RESULTS

of Conflict checking of TOP LEVEL ACCESS PLATFORMS (SECTOR 13) – New Version AT392169MQ

Done by Lasha Sharmazanashvili 30/03/2005

AT392169MQ - NTB $_$ 0007 (TB FEET COIL - SECTOR 14)

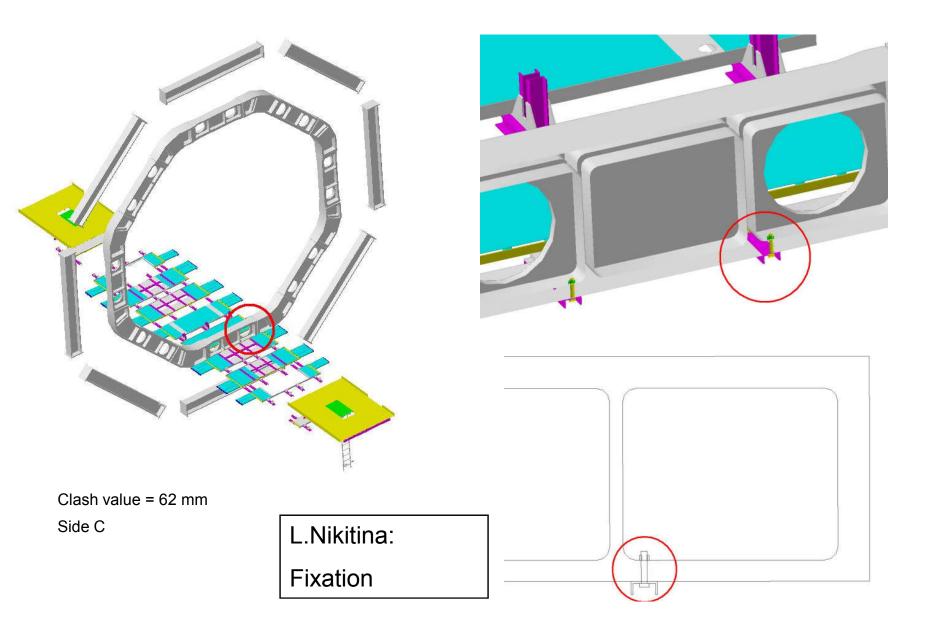
Platform	Toroid Magnets	Conflict	Value	Status	Revised with	Comments
1	AT392169MQ	NTB_0007 (TB FEET COIL - SECTOR 14)	Clash	-0.37	Not Relevant	L.Nikitina	Interface
2	AT392169MQ	NTB_0002 (TB FEET COIL - SECTOR 12)	Contact	-	Not Relevant	L.Nikitina	Interface
3	AT392169MQ	NTB0005 (TB WARM STRUCTURE - RING OF THE VOUSSOIRS, STRUTS)	Clash	-62.00	Not Relevant	L.Nikitina	Interface
4	AT392169MQ	NTB_0003 (TB WARM STRUCTURE - SIMPLIFIED 3-D OBJECT)	Clash	-98.81	Not Relevant	L.Nikitina	Interface

AT392169MQ - NTB__0005 (TB WARM STRUCTURE - RING OF THE VOUSSOIRS, STRUTS)

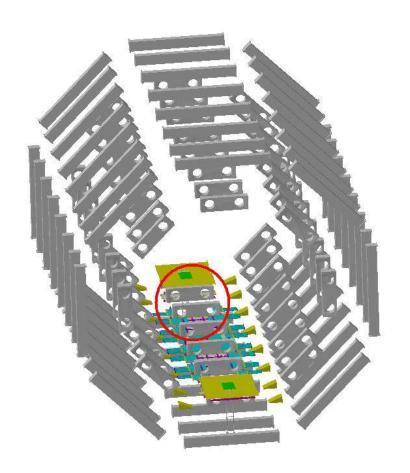
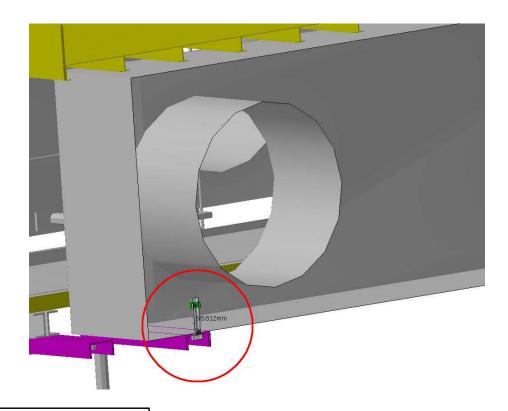
Clash value = 99 mm Side A

L.Nikitina:

Fixation

AT392169MQ / NMA__0019 (MEE CHAMBERS SIDE C - 3D SIMPLIFIED MODEL)

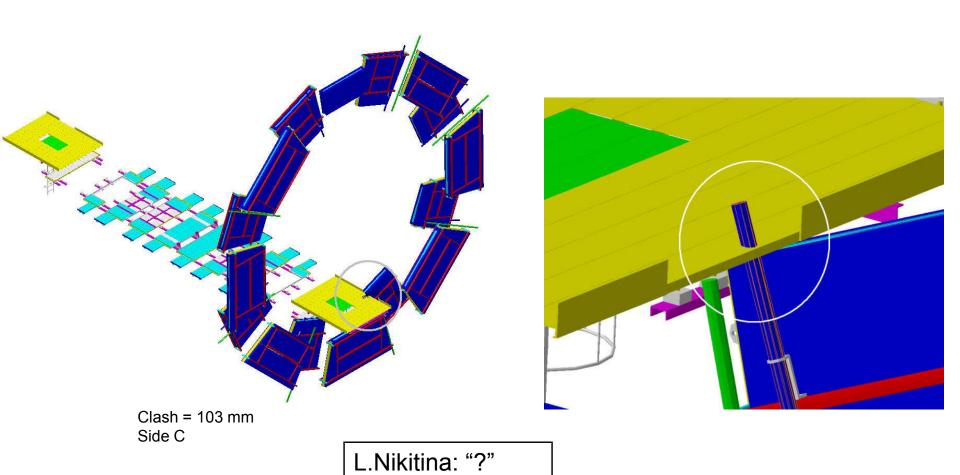
Platform	Toroid Magnets	Conflict	Value	Status	Revised with	Comments
1	AT392169MQ	NMC_0019 (MEE CHAMBERS SIDE C - 3D SIMPLIFIED MODEL)	Clash	103	Relevant	L.Nikitina	
2	AT392169MQ	NMA0007 (BARREL PROJECTIVE ALIGNMENT SIMPLE 3-D MODEL. SECTOR 13)	Clearance	3.87	Not Relevant	L.Nikitina	Platforms can be moved
3	AT392169MQ	NMA0009 (END CAP ALIGNMENT SIDE "A" SIMPLE 3-D MODEL)	Clearance	4	Relevant	L.Nikitina	
4	AT392169MQ	NMA0010 (END CAP ALIGNMENT SIDE "C" - SIMPLE 3-D MODEL)	Clearance	4	Relevant	L.Nikitina	
5	AT392169MQ	NMA0016 (SECTOR 12 SIDE C (A) - REFERENCE ALIGNMENT SYSTEM AND)	Clearance	21.61	Not Relevant	L.Nikitina	Platforms can be moved
6	AT392169MQ	NMA0017 (SECTOR 14 SIDE C (A) - REFERENCE ALIGNMENT SYSTEM AND)	Clearance	21.61	Not Relevant	L.Nikitina	Platforms can be moved

AT392169MQ / NMA_0007 (BARREL PROJECTIVE ALIGNMENT. - SIMPLE 3-D MODEL. SECTOR 13)

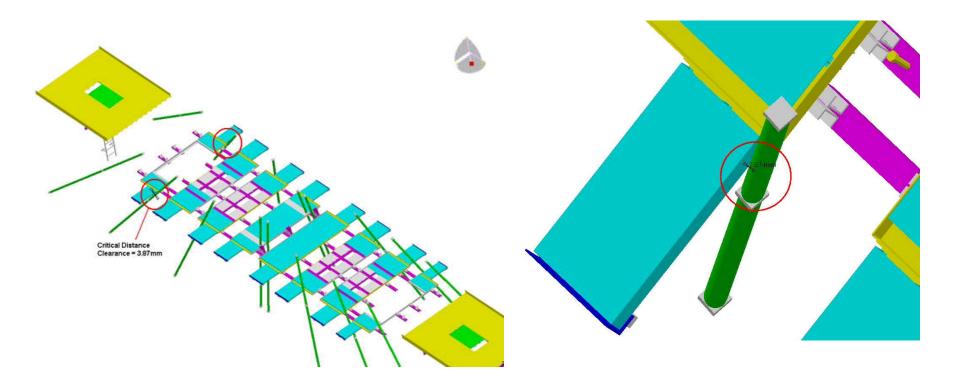
Critical distance = 3.87mm Side A

Same conflict occurs on Side C

L.Nikitina:

Mobile platforms

AT392169MQ / NMA__0010 (END CAP ALIGNMENT SIDE "C" - SIMPLE 3-D MODEL)

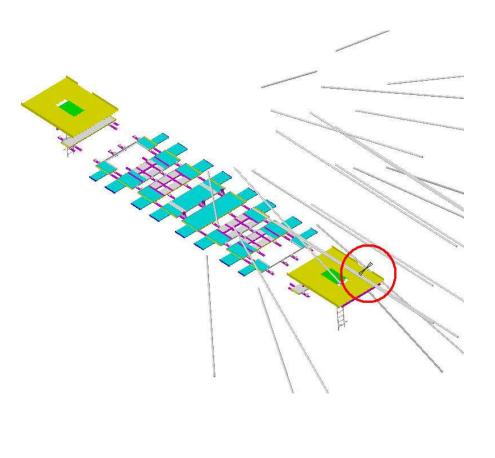
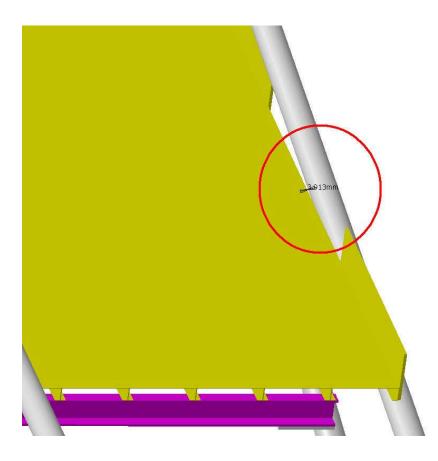
Critical Distance = 4 mm Side C

AT392169MQ / NMA__0016 (SECTOR 12 SIDE C (A) - REFERENCE ALIGNMENT SYSTEM AND)

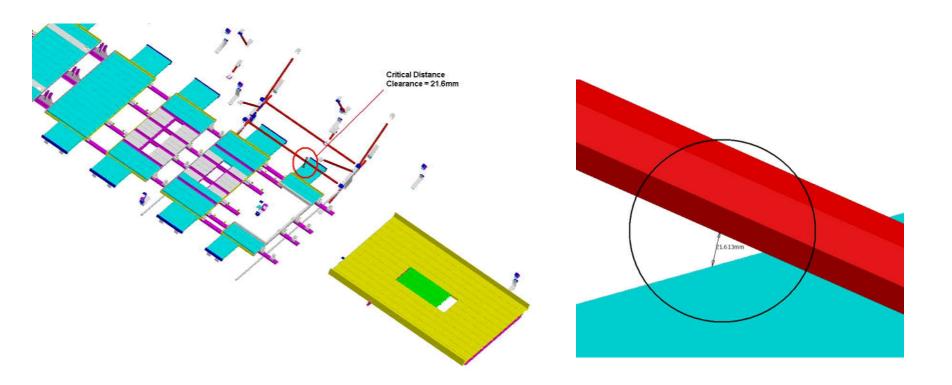
Critical Distance = 22 mm Side C

AT392169MQ / NMA__0017 (SECTOR 14 SIDE C (A) - REFERENCE ALIGNMENT SYSTEM AND)

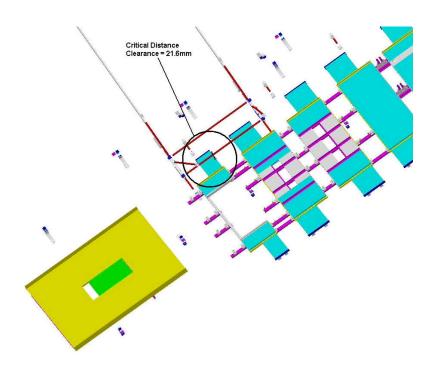
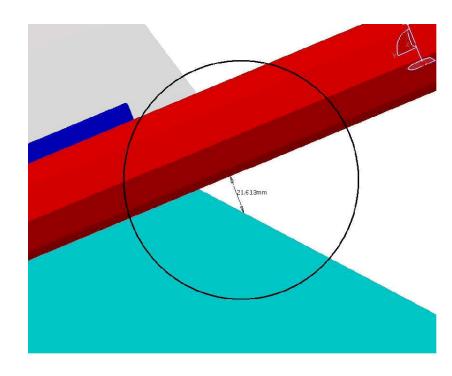
Critical Distance = 22 mm Side A
